Trinity Islands Site C, Manchester

Non-Material Amendment | 21.01.2026

ZC-SHP-A180-RP-XX-NMA01 | P01

Updated proposal : Site C Building 1 - Elevations 01 - C1-SHP-G200-EL-XX-B5D801 - P03

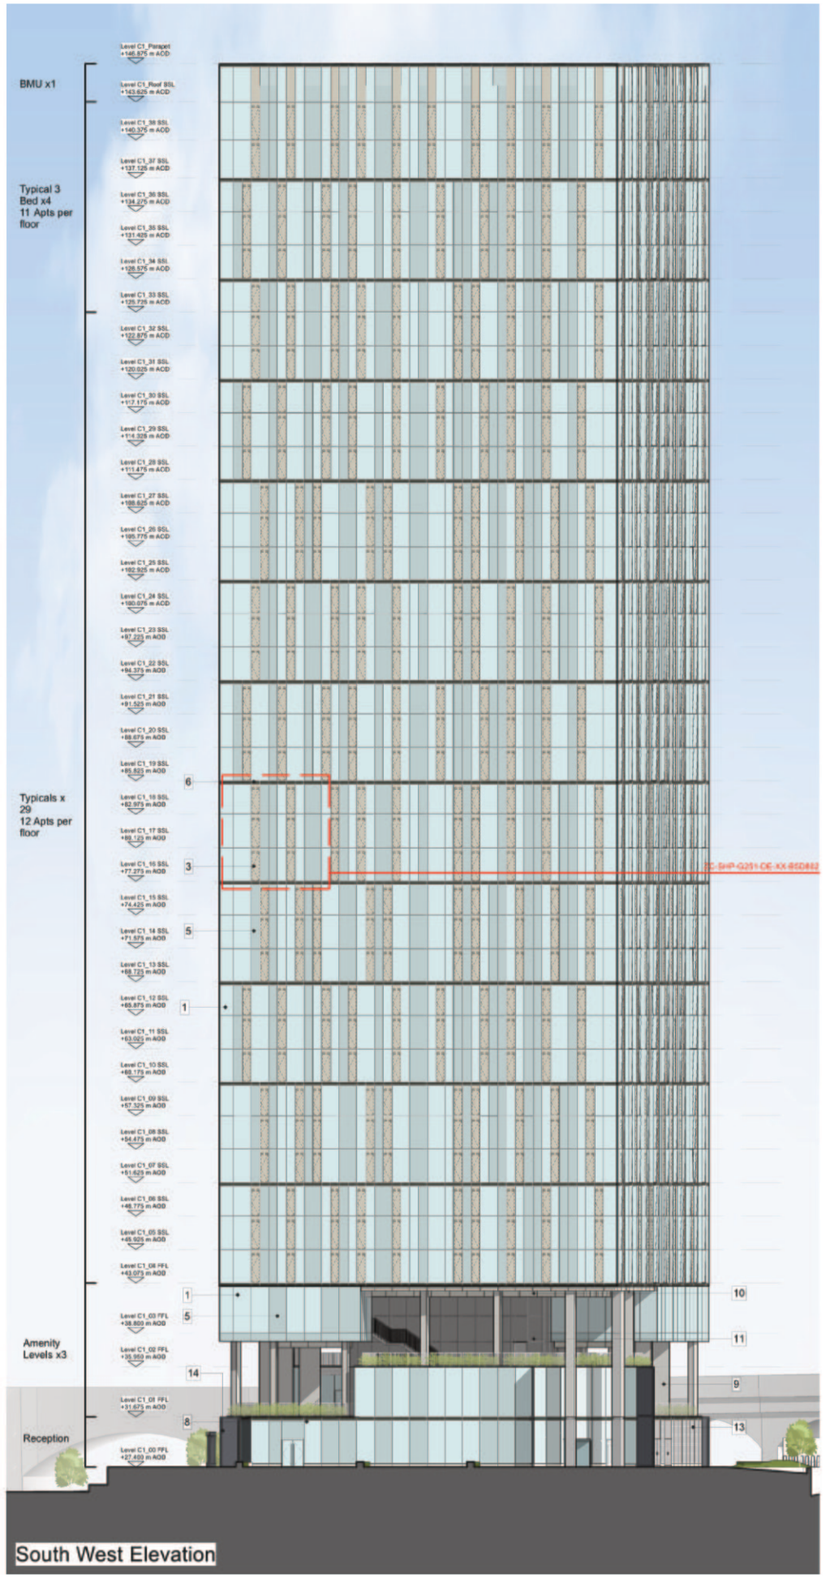
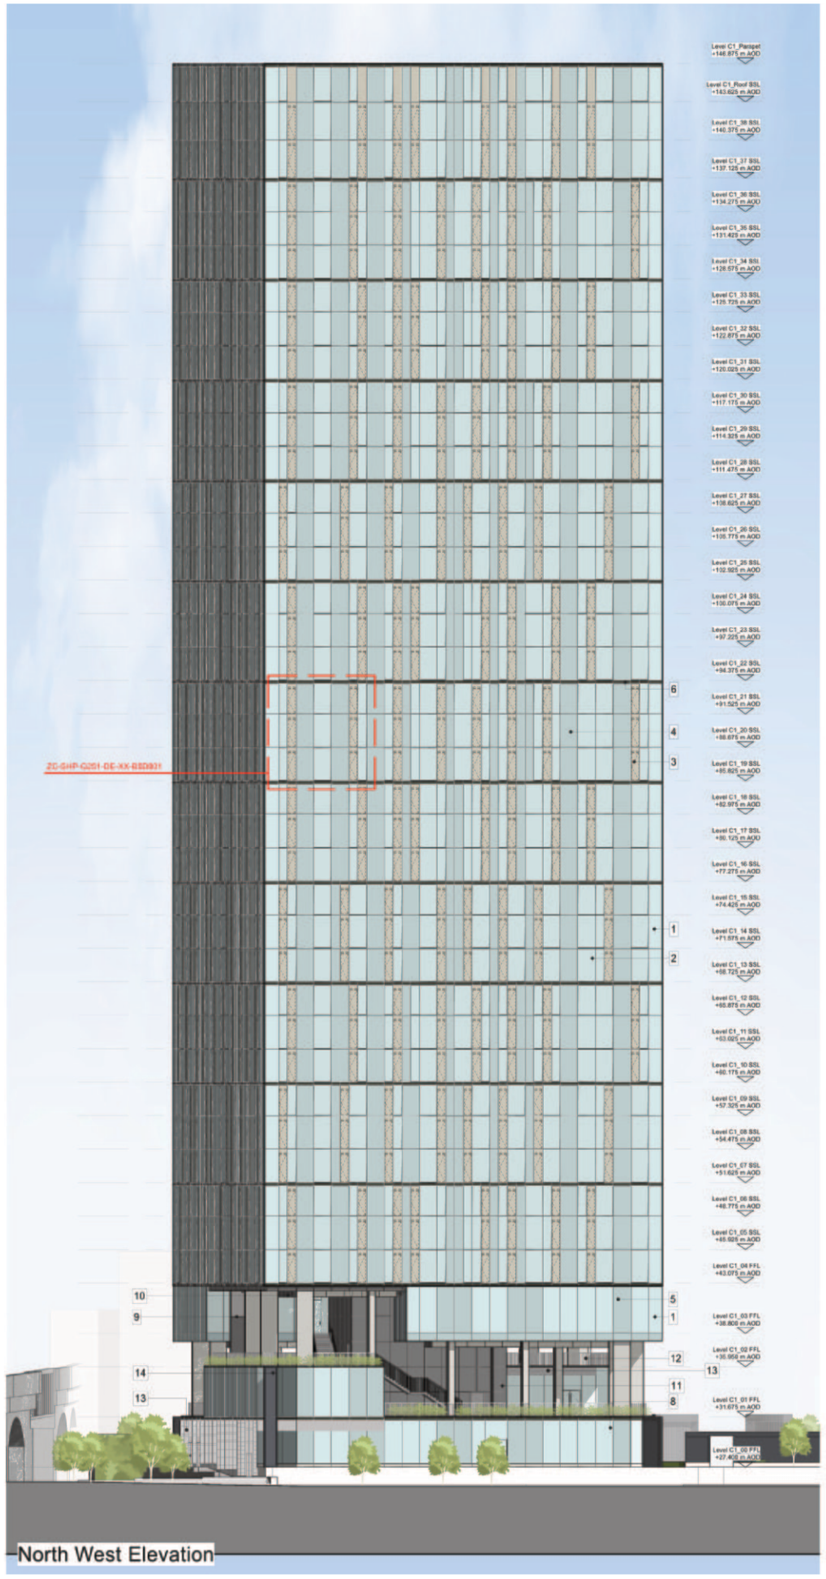
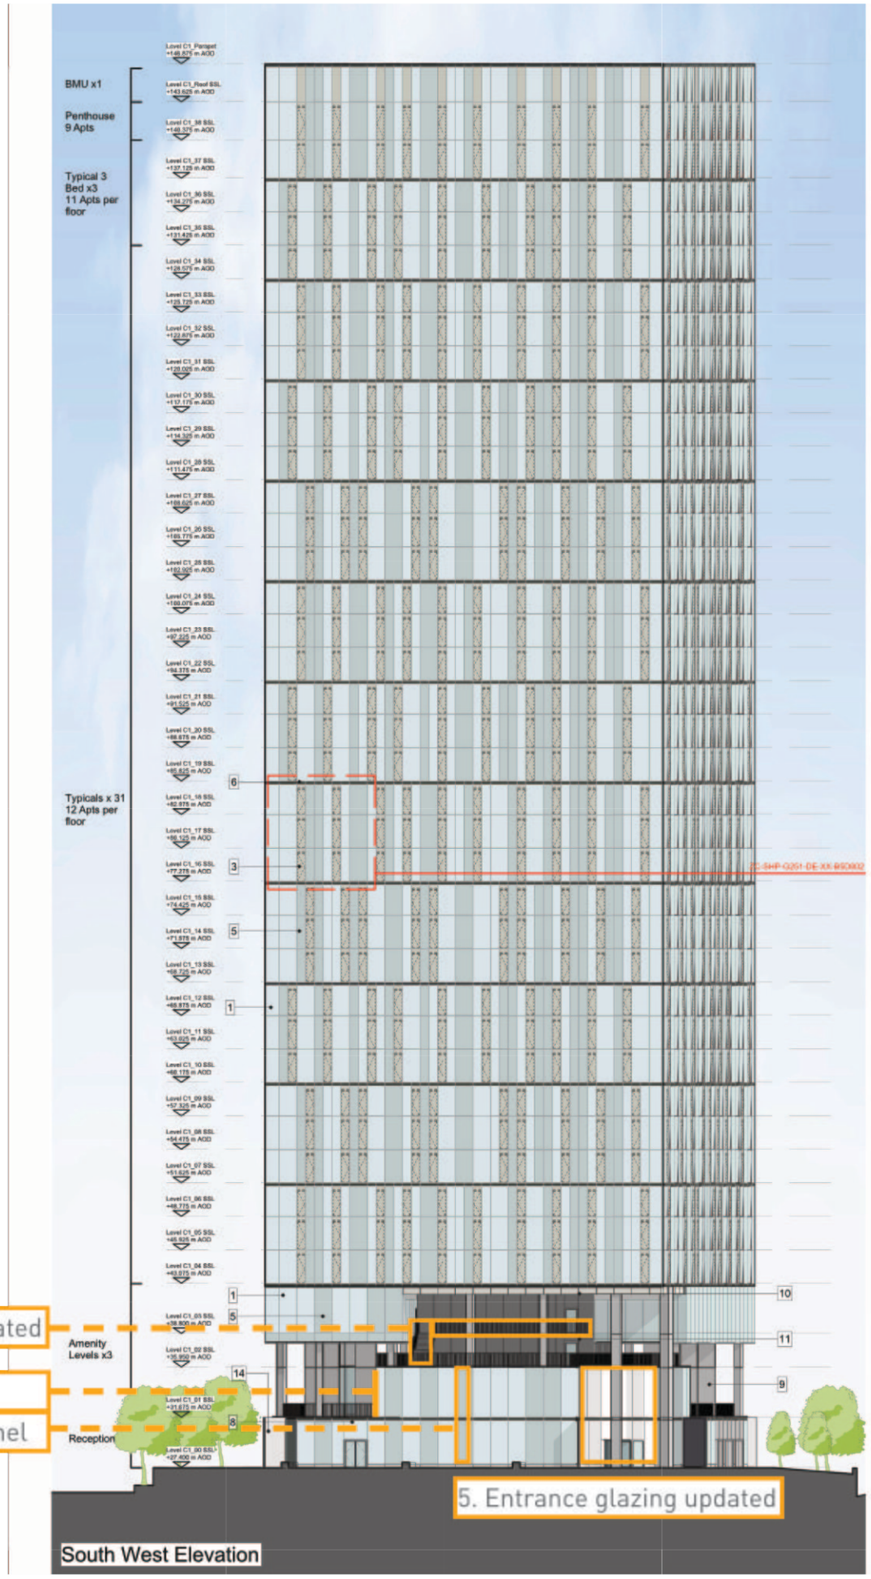
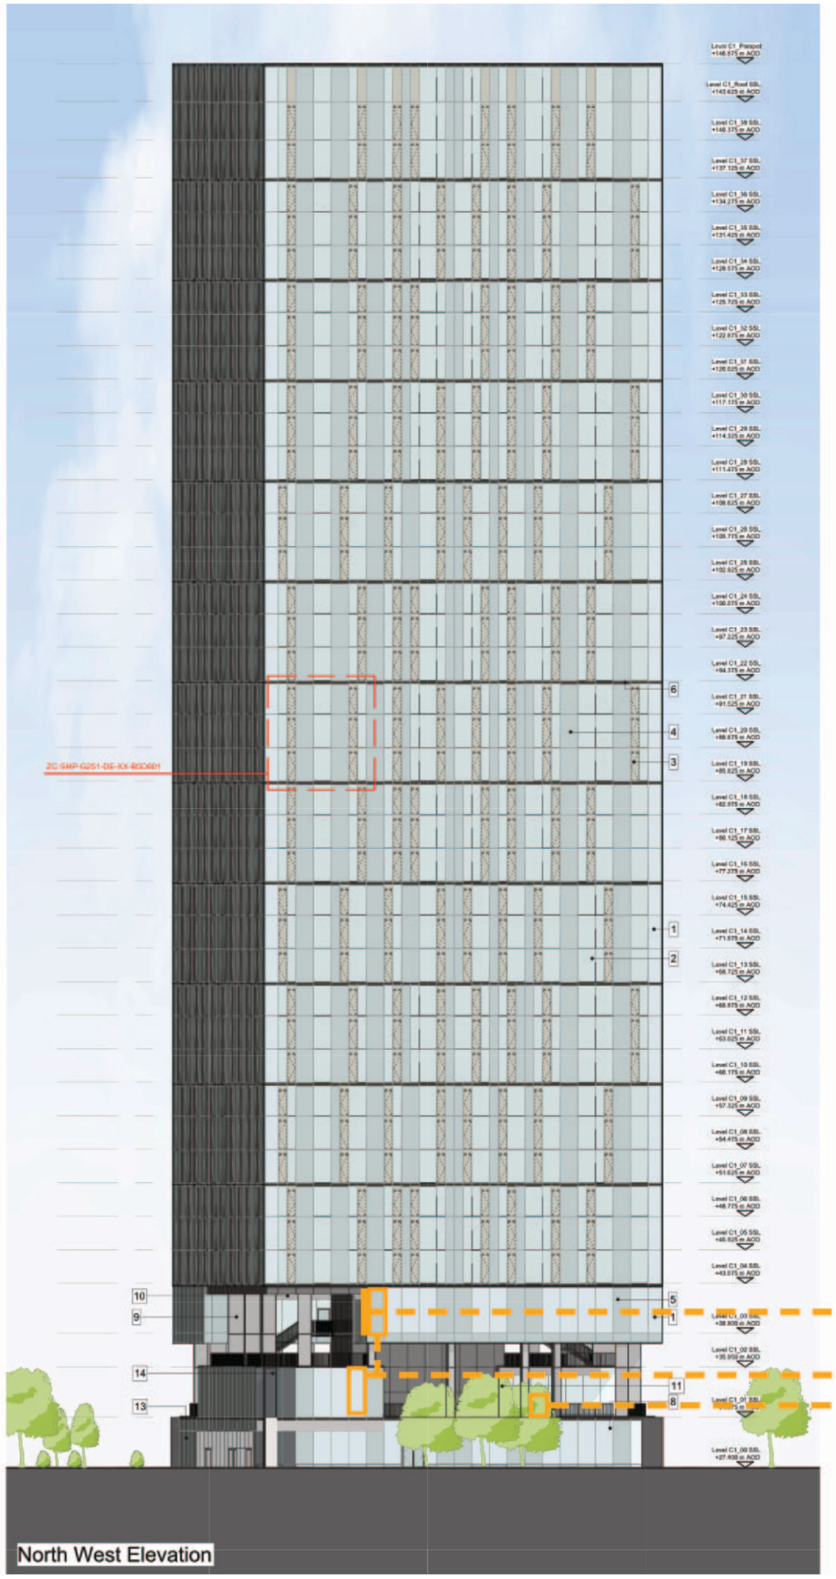
4. External stair/walkway updated

5. Facade line updated

5. Additional opaque panel

Updated proposal : Site C Building 1 - Elevations 02 - C1-SHP-G200-EL-XX-B5D802 - P03

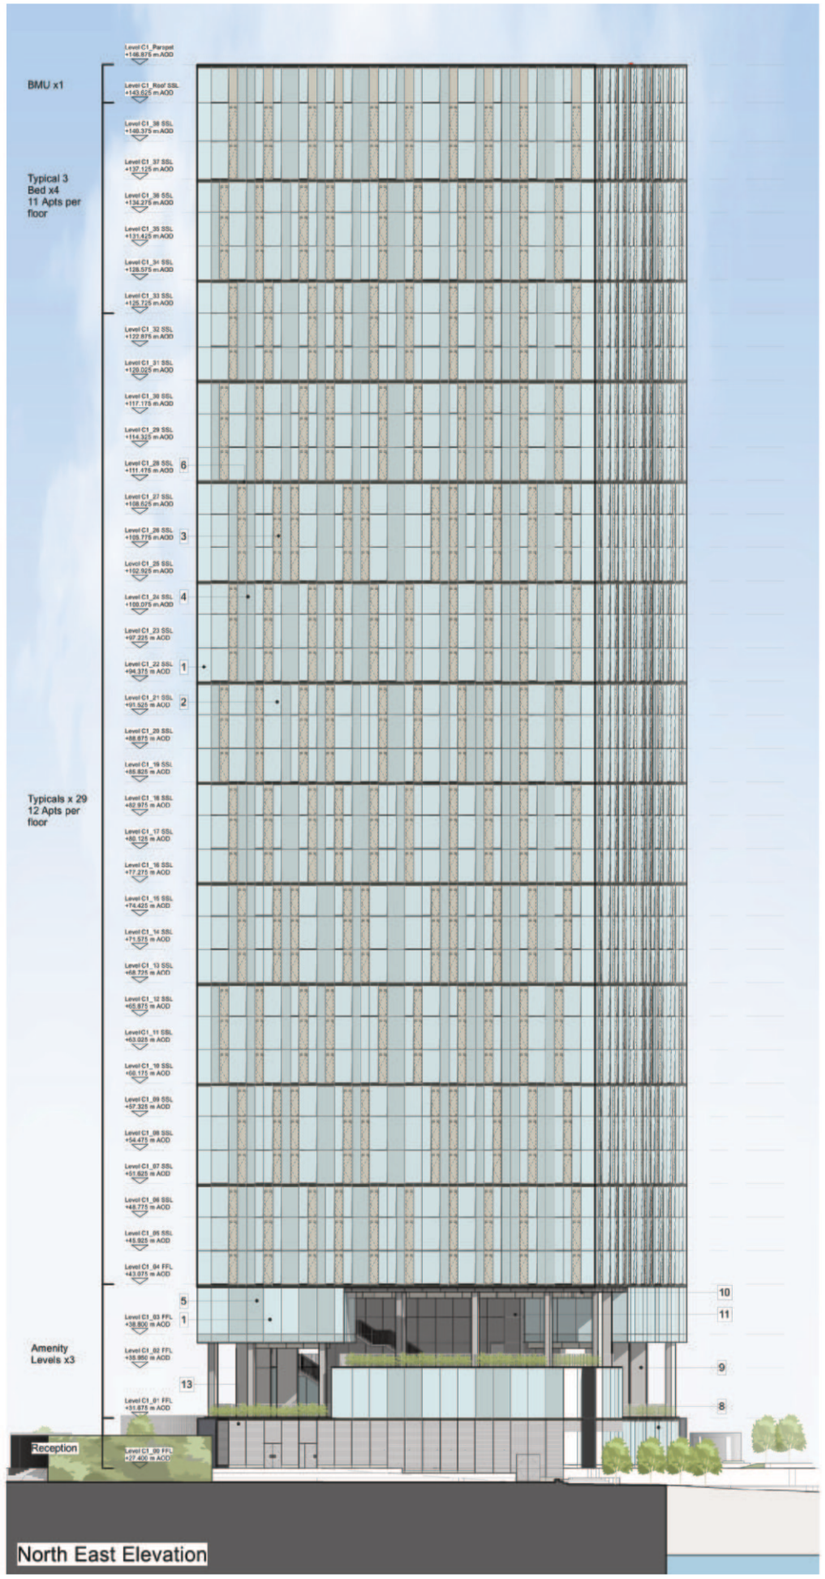
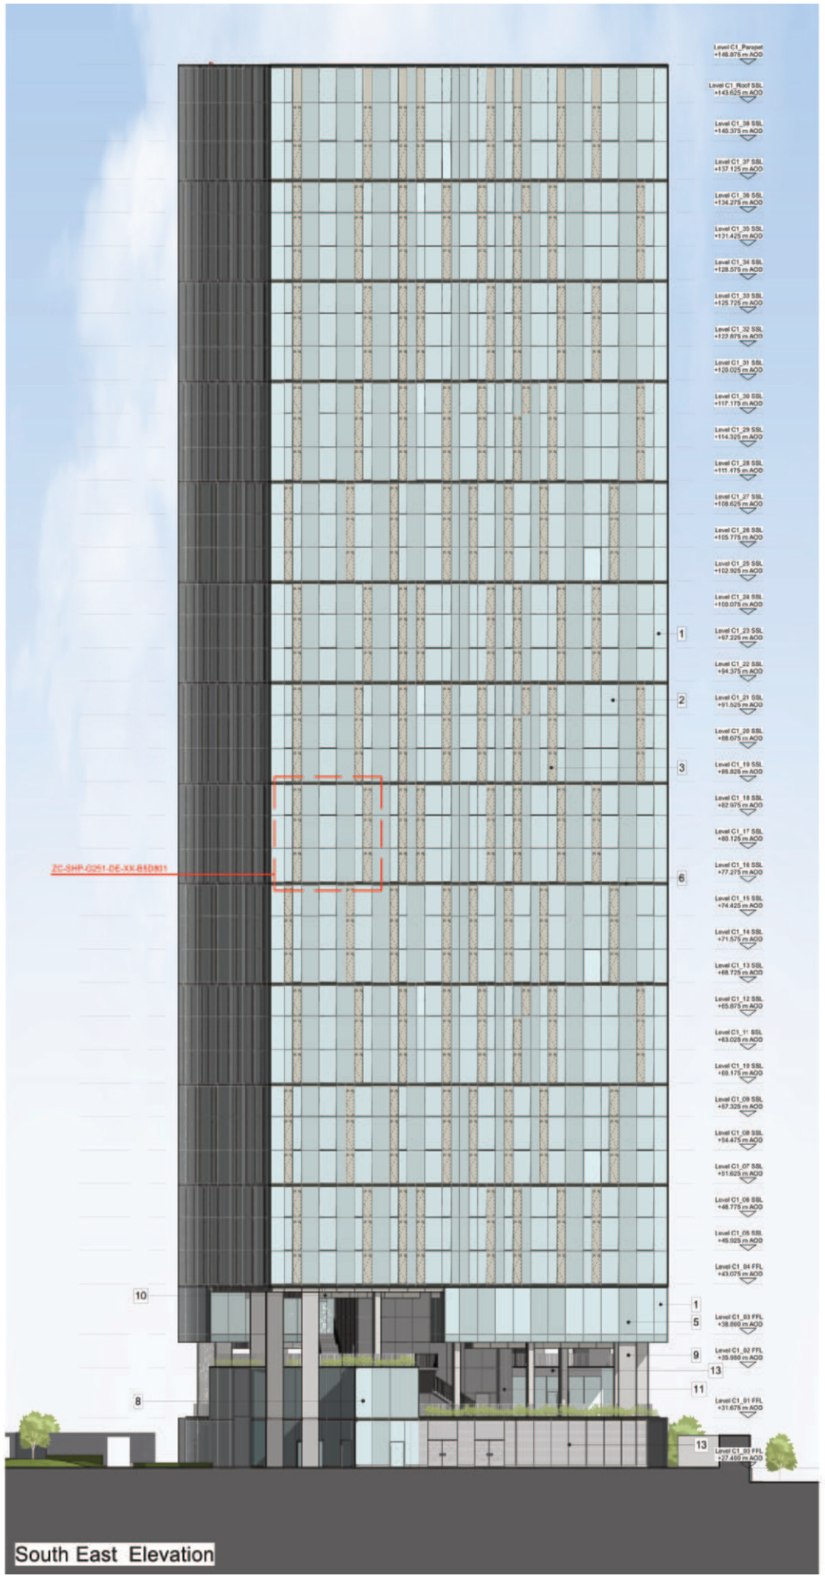
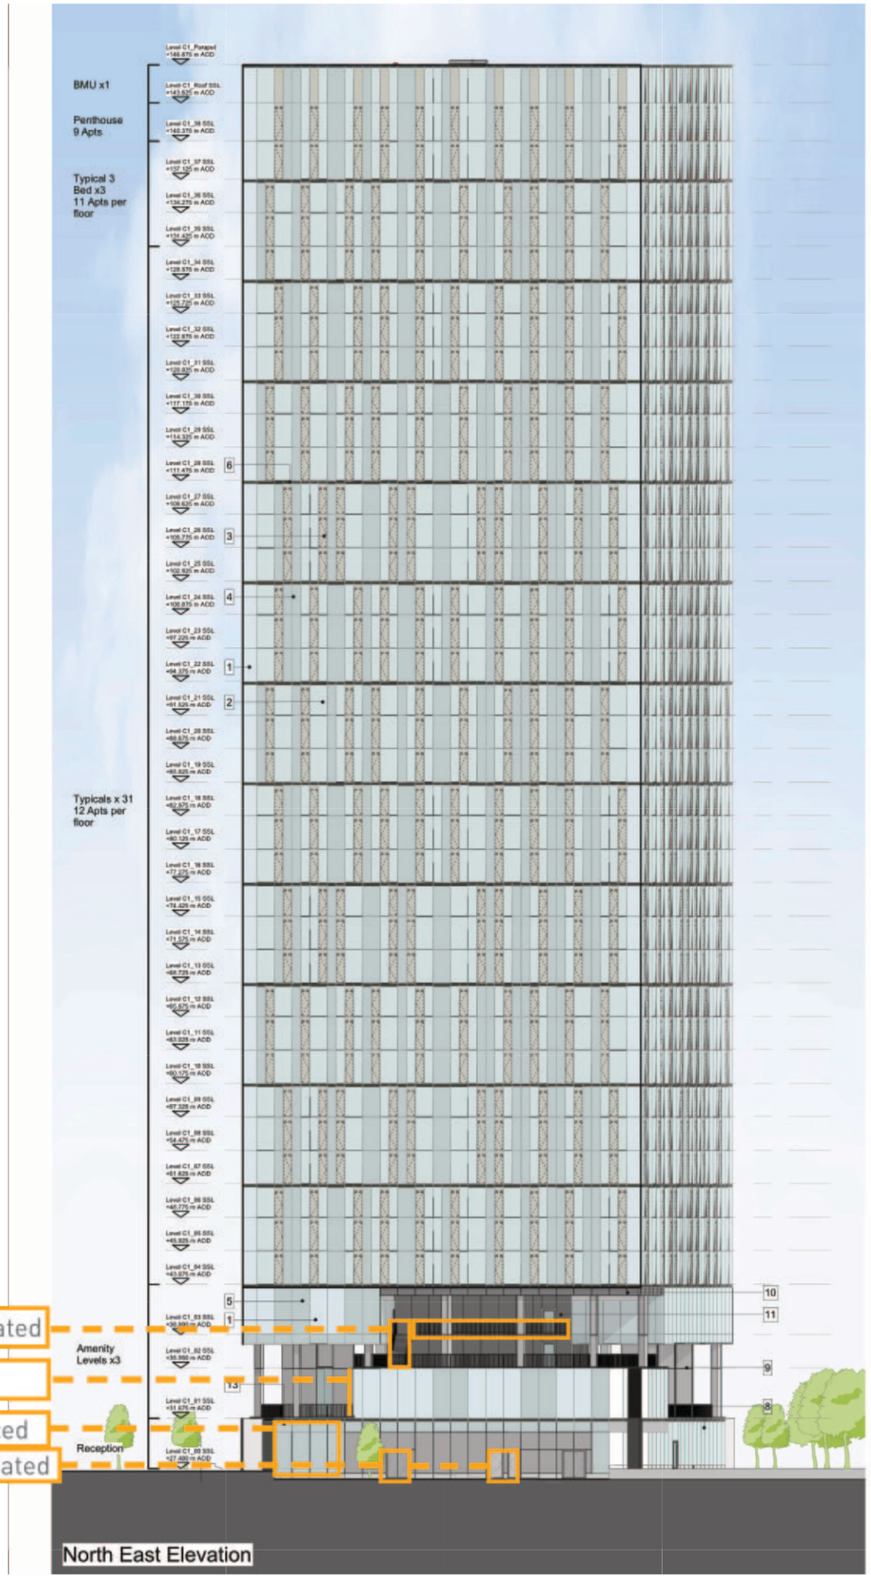
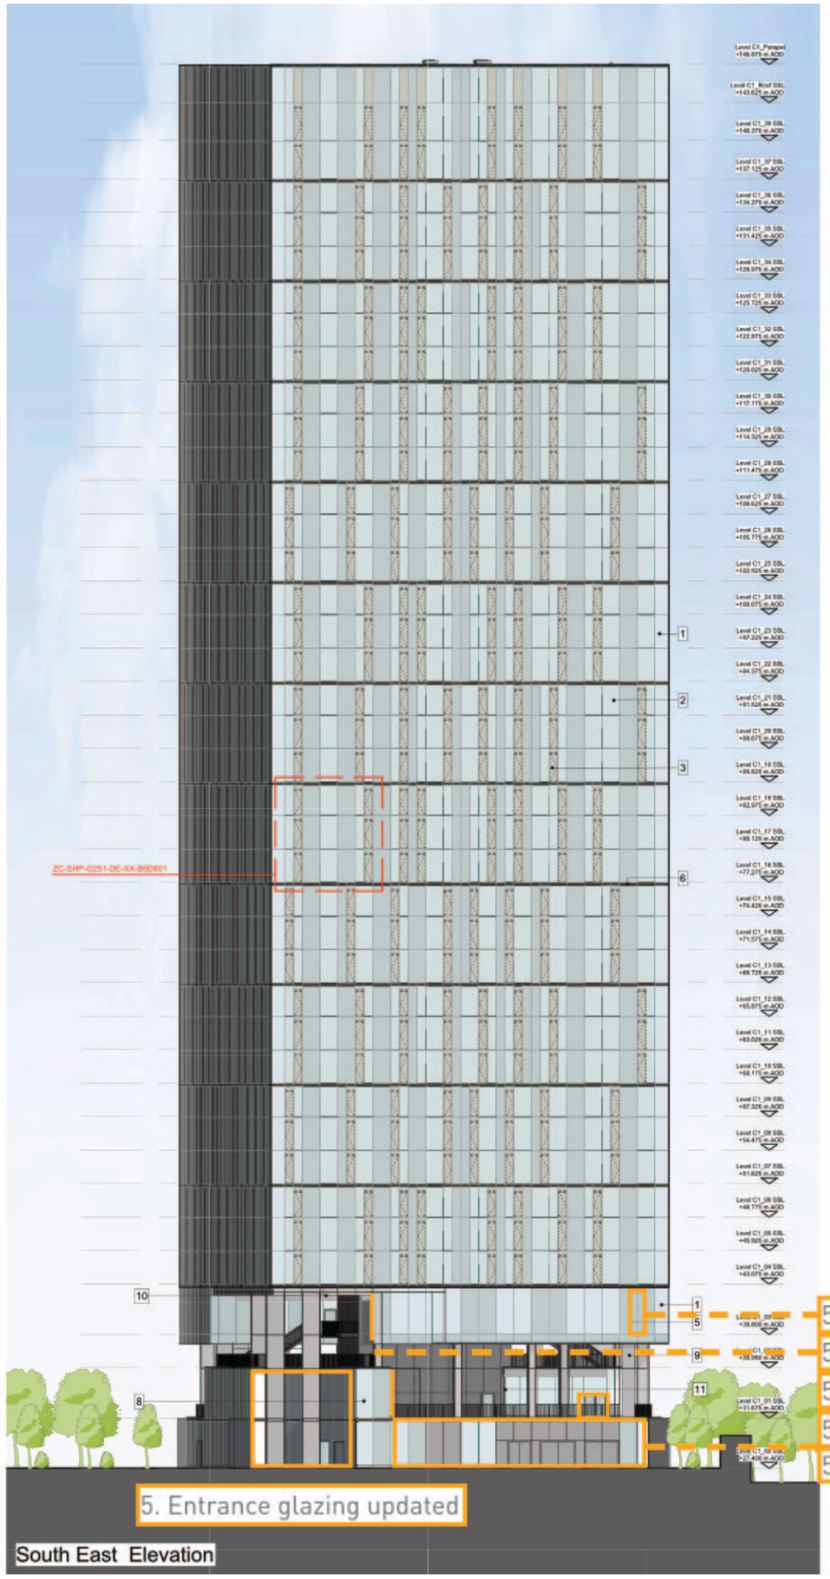
5. Entrance glazing updated

5. Facade line updated

5. Additional opaque panels

5. Door position updated

4. External stair/walkway updated

5. Facade line updated

5. Louvre panel extent reduced

5. Louvre door positions updated

5. Additional opaque panel

5. Facade line updated

5. Door position updated

5. Louvre panel extent reduced

5. Louvre door positions updated
